Schedule I
Reconstruction of Taxiway F

Transmitted herewith is Addendum **No. 2** to the Issued for Bid Contract Documents, Specifications and Plans dated May 25, 2023 for Improvements to the Oxnard Airport.

**ADDENDUM NO. 2 TO
CONTRACT DOCUMENTS, SPECIFICATIONS AND PLANS
FOR IMPROVEMENTS TO THE
OXNARD AIRPORT
OXNARD, CALIFORNIA
AIP PROJECT NO. 3-06-0179-043-2023
COUNTY OF VENTURA DOA SPEC. NO. OXR 23-03, PROJECT NO. OXR-150**

ELECTRICAL LAYOUT PLAN
 STA. 124+00 TO STA. 137+00
 RUNWAY 7/25

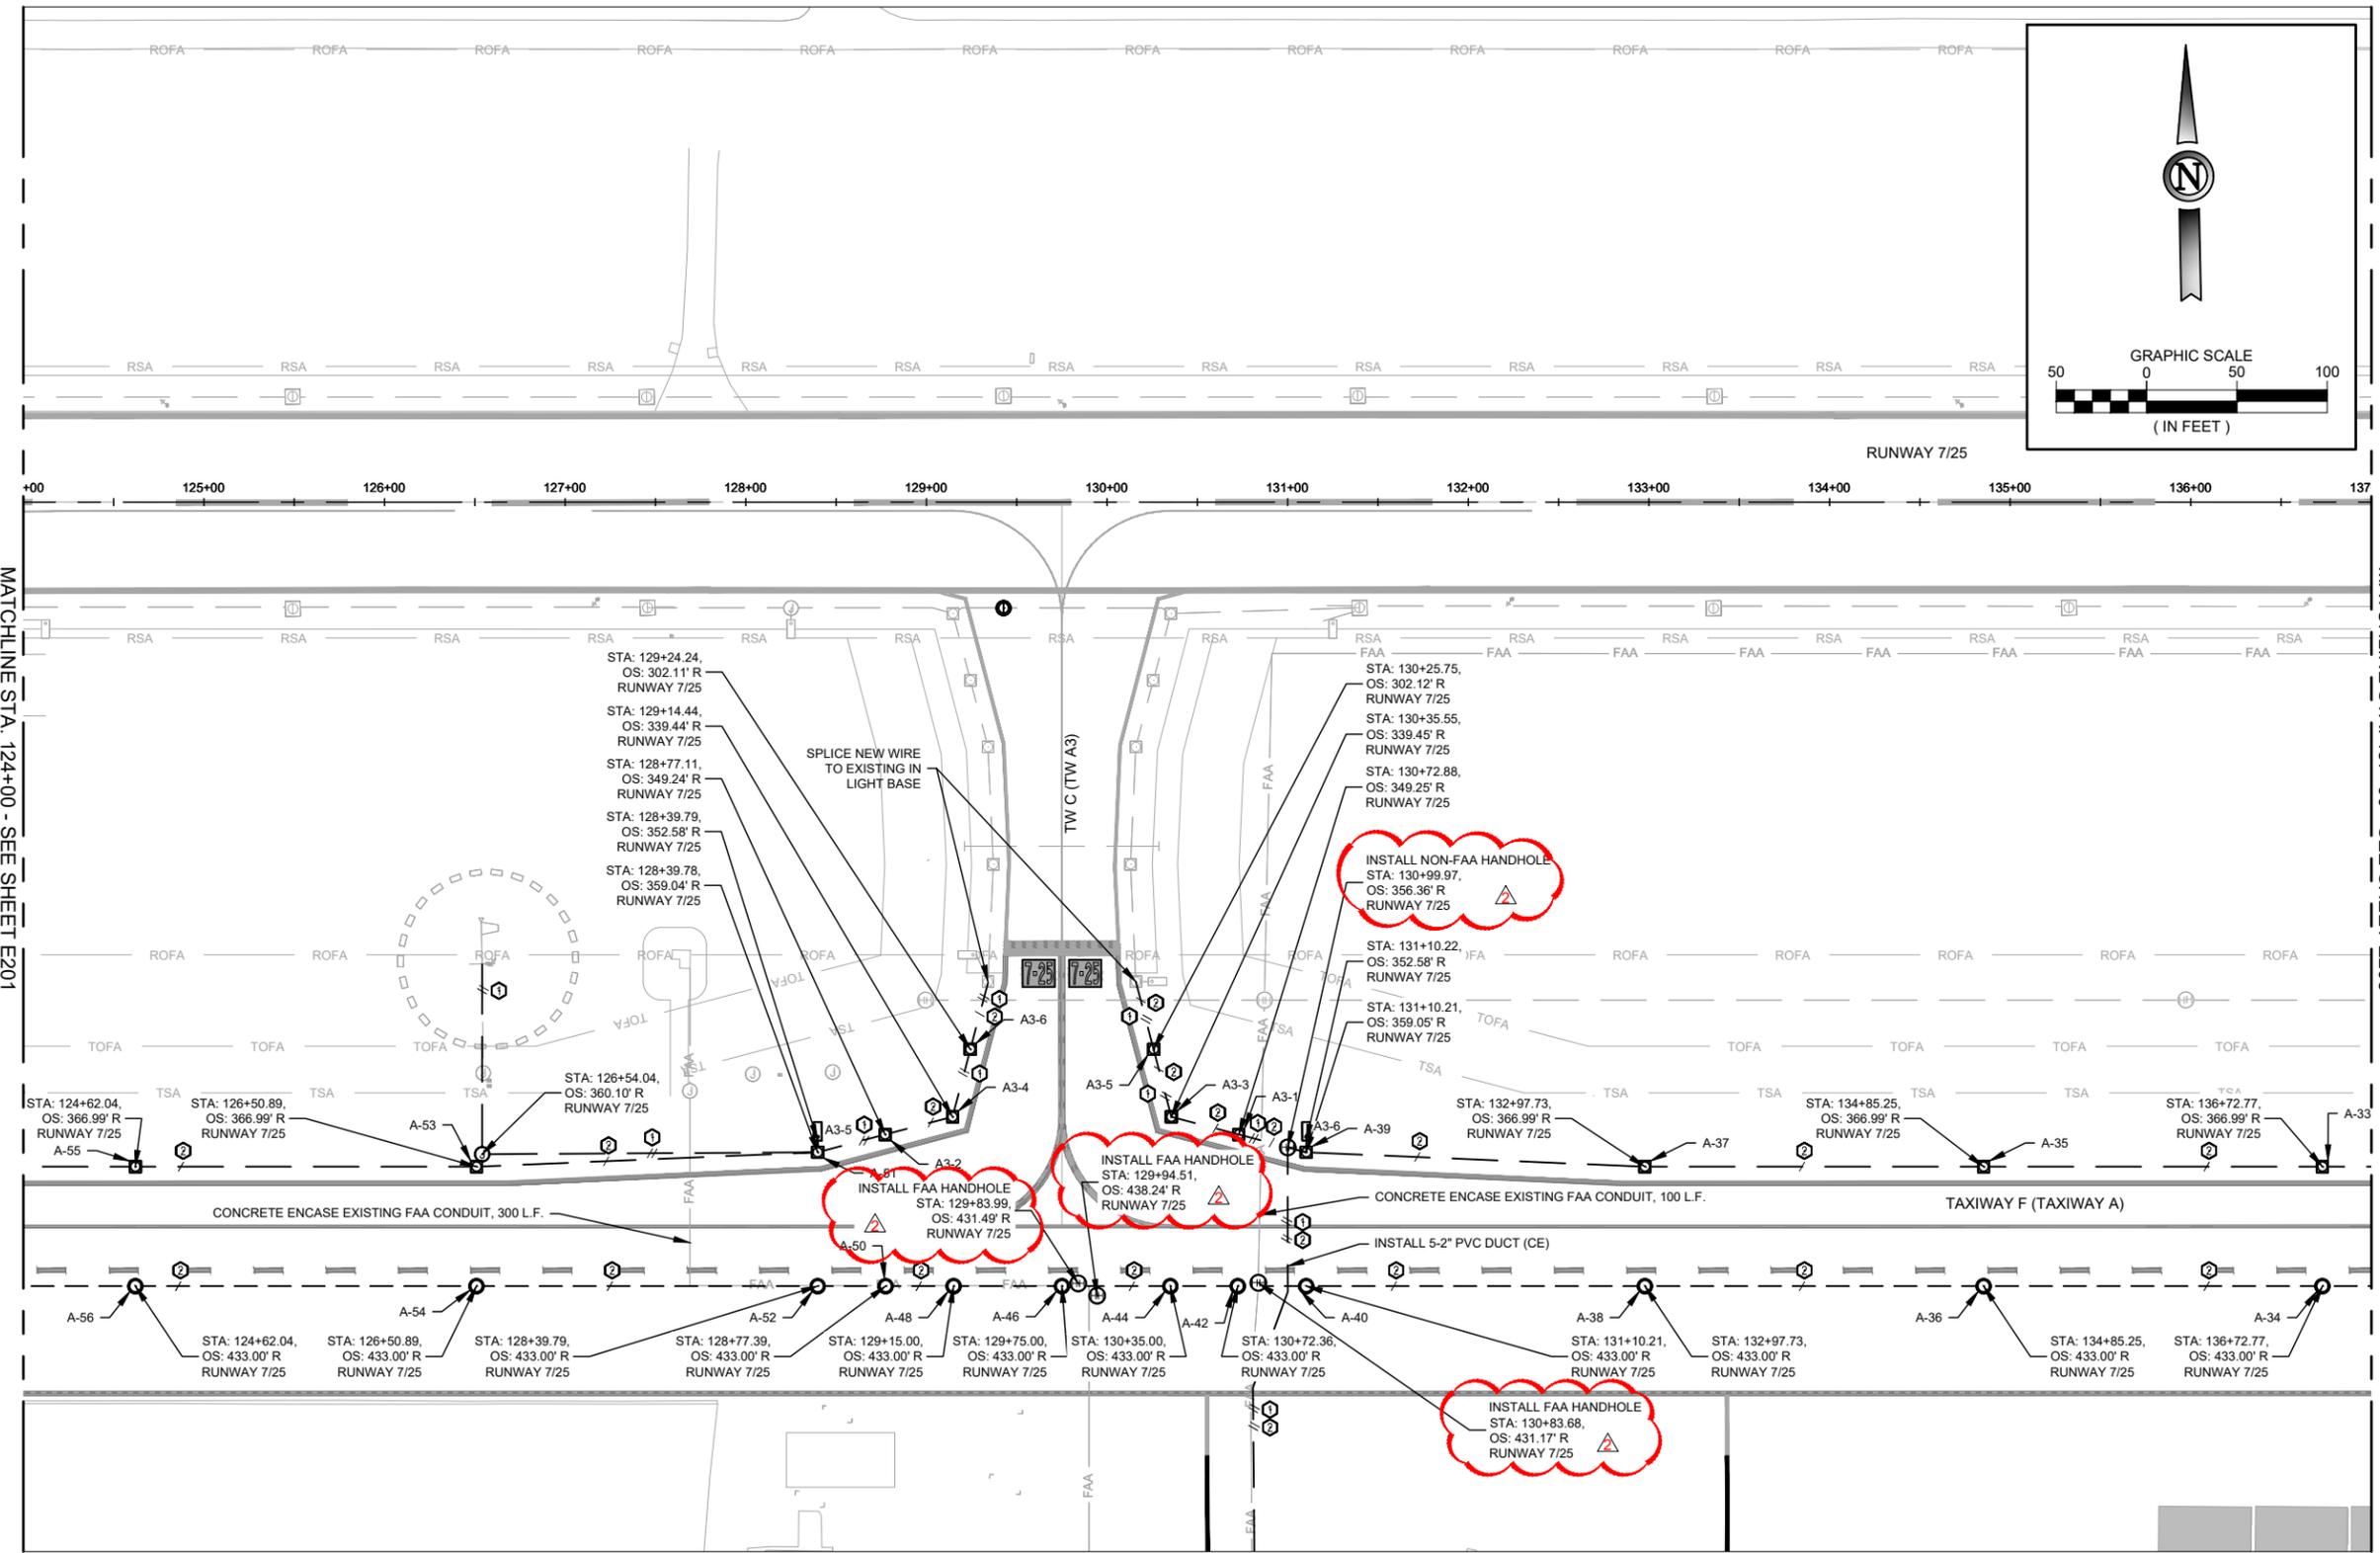
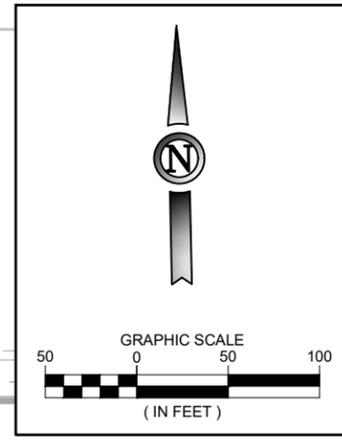
Sheet E202, ELECTRICAL LAYOUT PLAN STA. 124+00 TO STA. 137+00 RUNWAY 7/25. The callouts for the pullboxes were updated to show the FAA and NON-FAA electrical pullboxes.

- 7) Question: On Plan Sheet E202, is the 5-2" PVC Duct (CE) to be directionally bored under the existing pavement?

Justification: The FAA and NON-FAA pullboxes are different sizes.

Answer: The 5-2" PVC Duct (CE) will not be directionally bored under the existing pavement. This duct will be installed within the proposed pavement limits and tie to the existing duct bank at the edge of the limit.

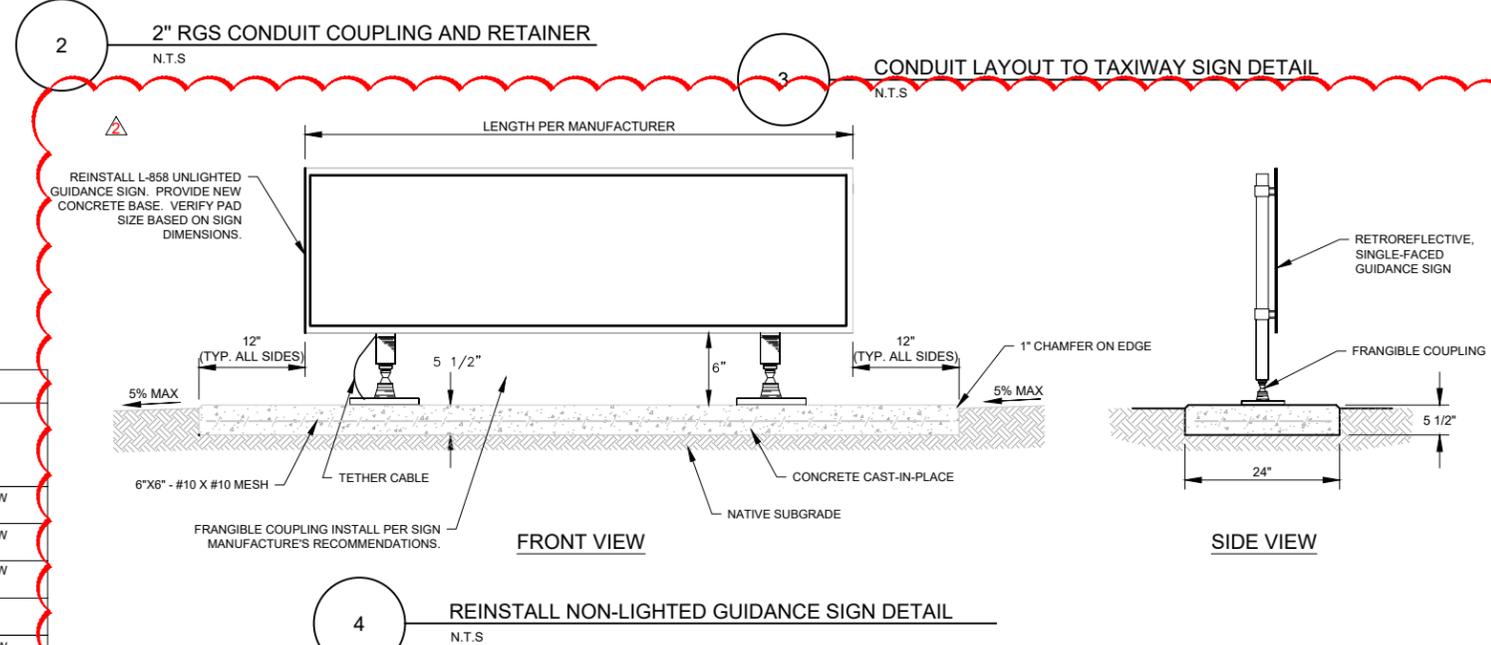
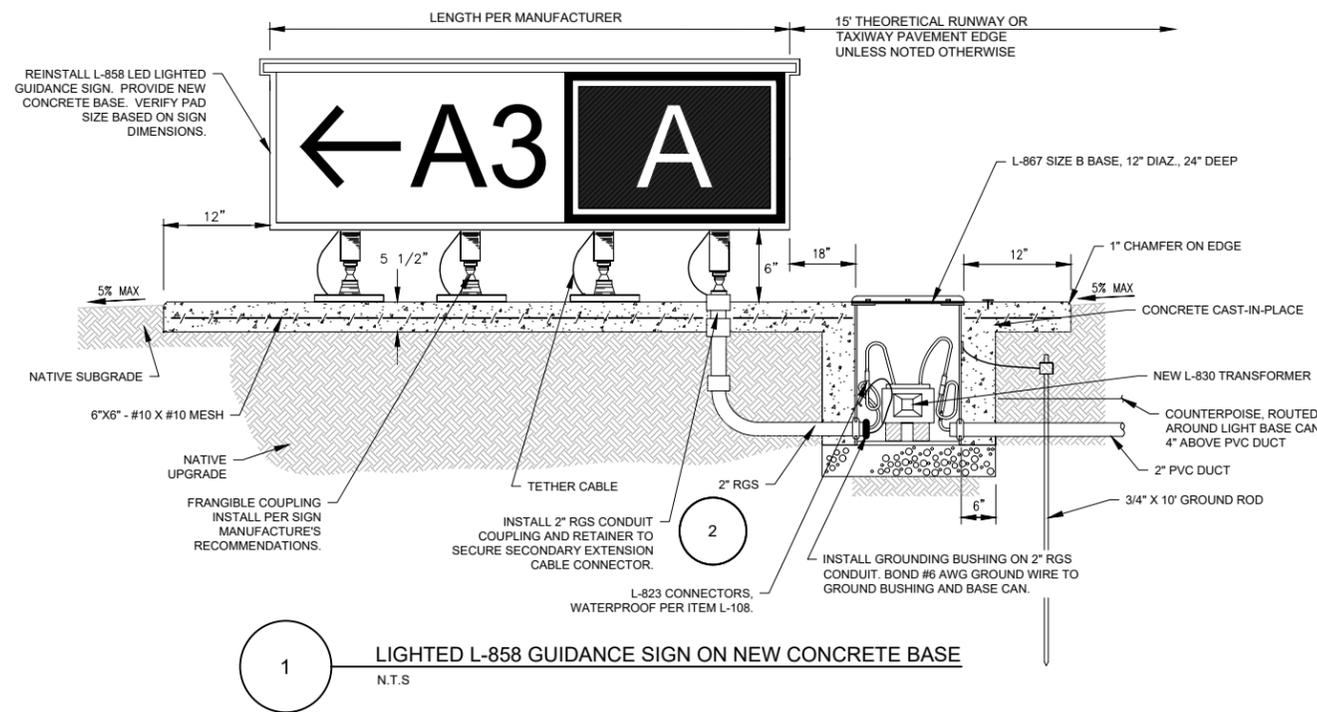
Sheet E252, ELECTRICAL DETAILS. Detail 4 was added to the sheet to show the reinstatement of the unlighted billboard sign.

Justification: The unlighted sign will be removed and reinstalled on a new foundation.

SHEET NAME
E253
 SHEET NO.
89 of 89
 DRAWING NO.
1674-DOA

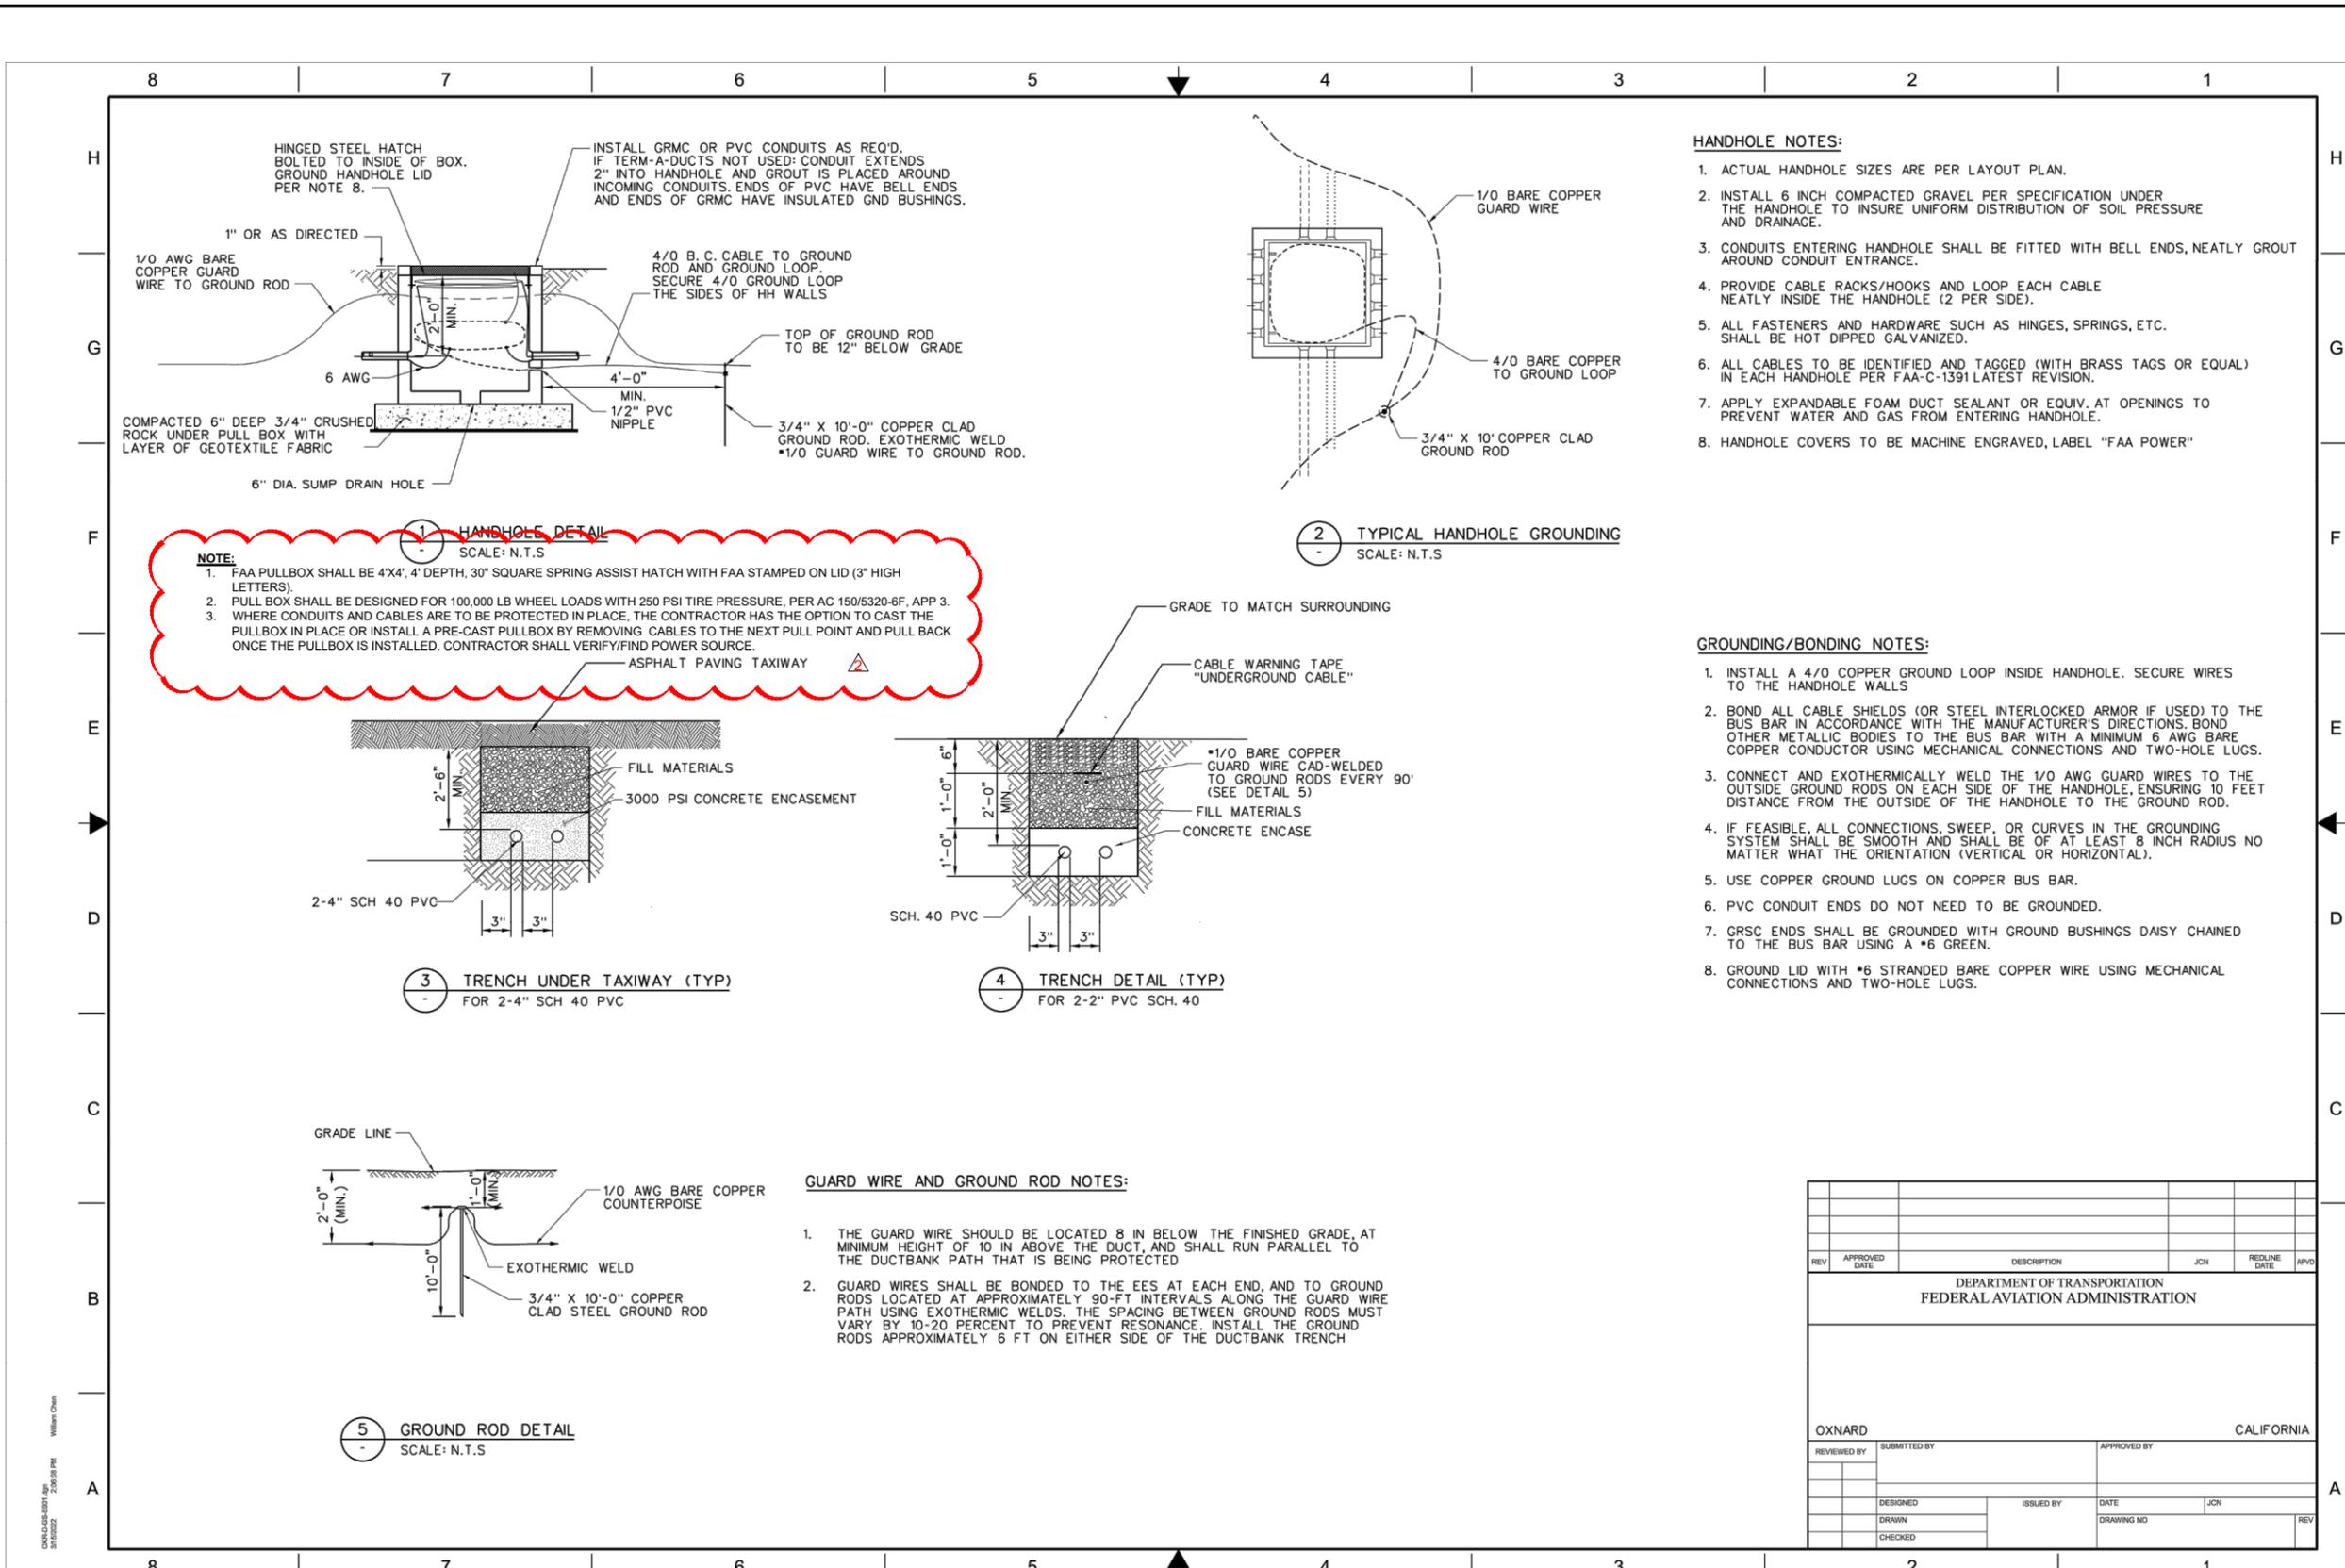
Sheet E253, ELECTRICAL DETAILS. Notes were added to Detail 1, Handhole Detail.

Justification: The FAA handholes shall be aircraft rated, and dimensions were added.
